REMARKS/ARGUMENTS

Appl. No. 10/622,082
Amdt. dated October 18, 2005
Reply to Office action of July 18, 2005

Title: INFLATABLE SUPPORT SYSTEM

Fig. 3

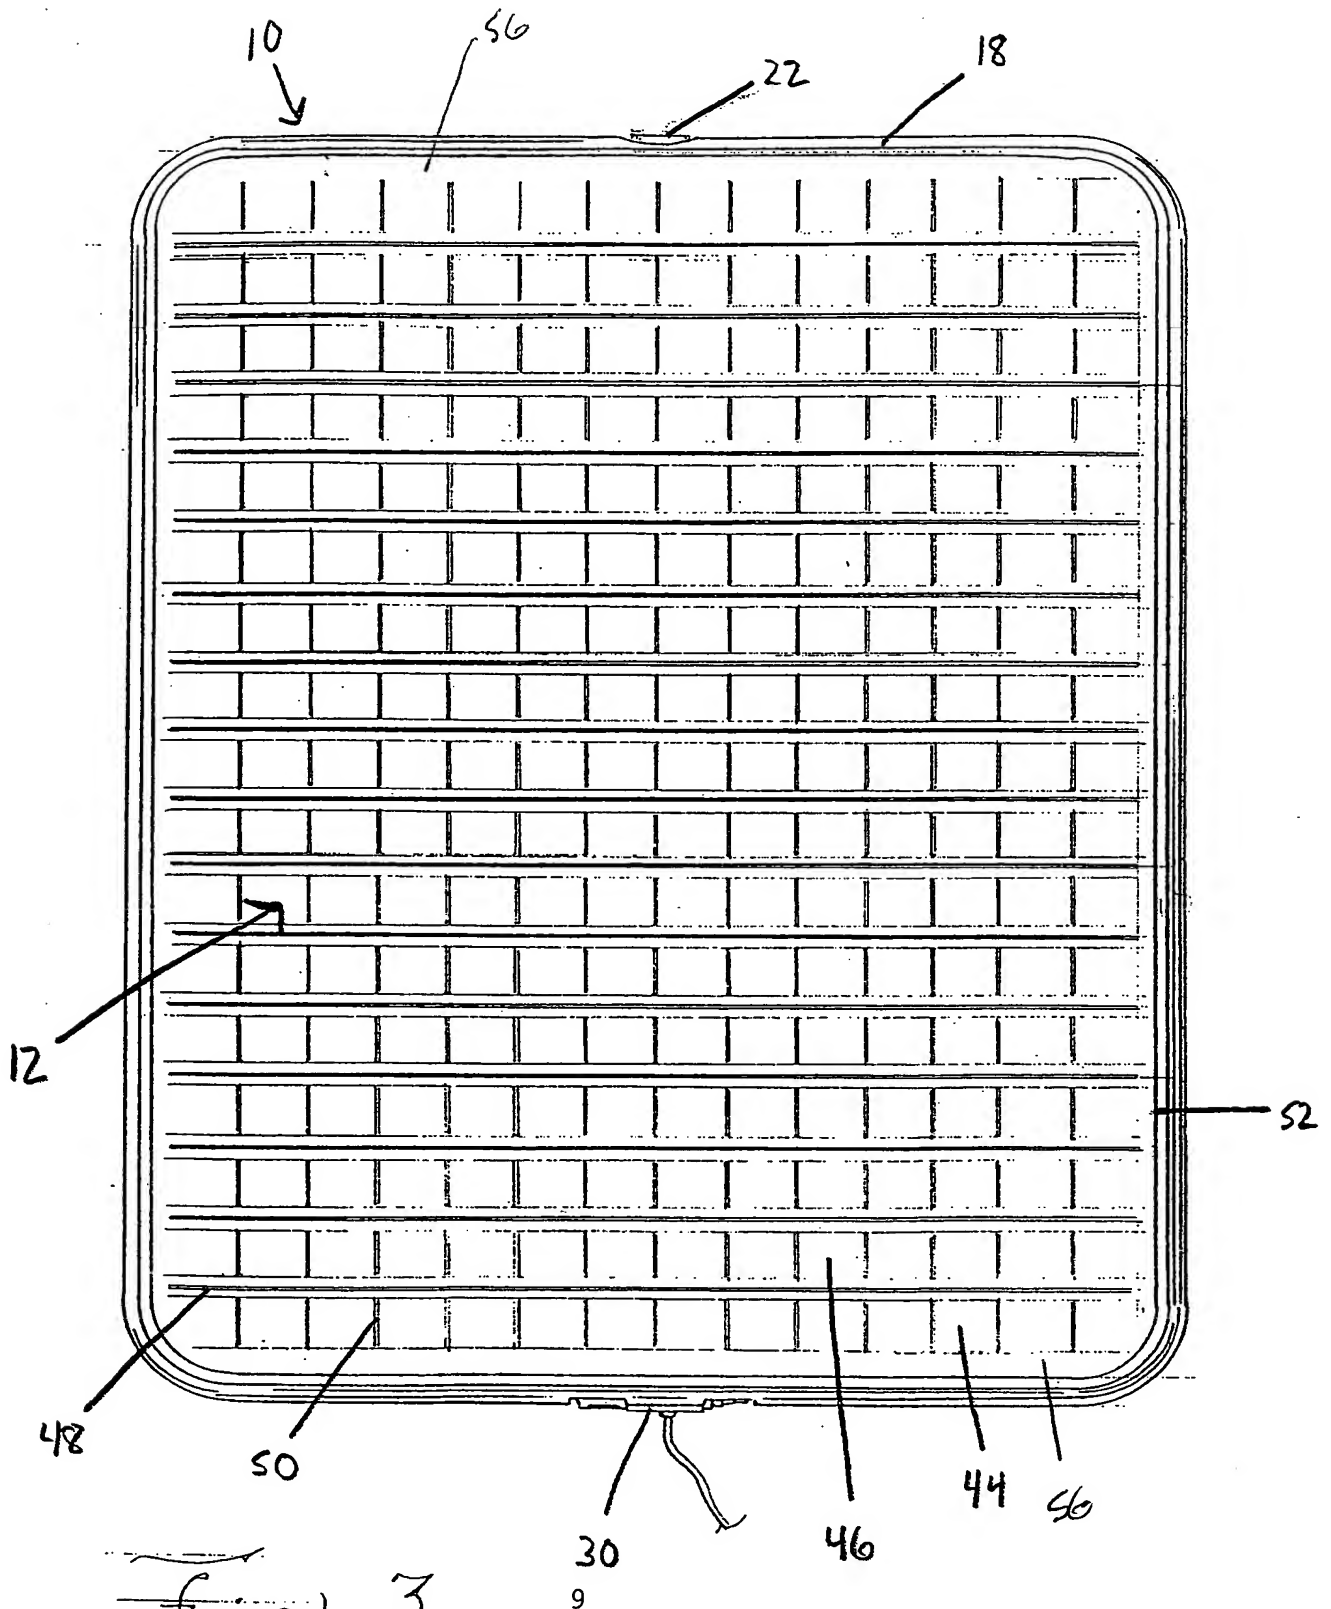
The Examiner has objected to the drawings because they do not contain reference numbers 45 and 56. Paragraph [0038] has been amended to correct a typographical error. The reference numeral "45" should be reference numeral "46." Figure 3 has been corrected to add reference numeral 56 to the figure.

The Examiner has also objected to the drawings because of improper labeling of Figure 12. Figure 12 has been corrected in the following manner: number 16 has become 36, number 20 has become 38, number 36 has become number 16, and number 38 has become 20.
